Product Change Notification

Change Notification #: 107800 - 00
Change Title: Intel® Celeron® Processors, PCN 107800, Product Material, Fan Heatsink Clip Removal
Date of Publication: August 10 , 2007

FCLGA4-M Original

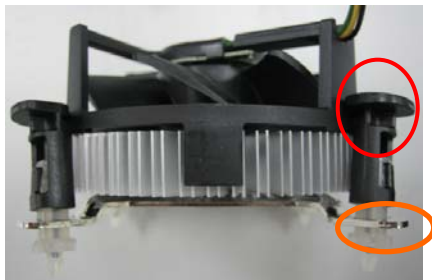
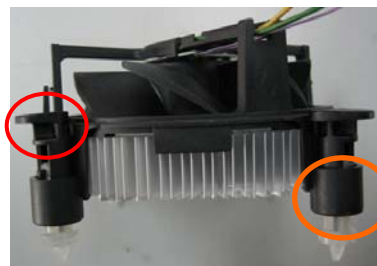
The heatsink shipped with these boxed processors has been modified. The fasteners mounted on X-Clip of the FCLGA4-M will now be mounted on the leg of the fan shroud of the FCLGA4-M clip-less. The fasteners position has not been changed.

Current X clip heatsink
for illustration purposes only

Modified clip-less heatsink
for illustration purposes only

None. The clip-less design solution looks slightly different than the X clip design. There is no change to the installation or thermal performance of this heatsink. The fastener position has not changed. Intel asks that you accept these processors interchangeably. All boxed processors are covered by Intel's three-year limited warranty.
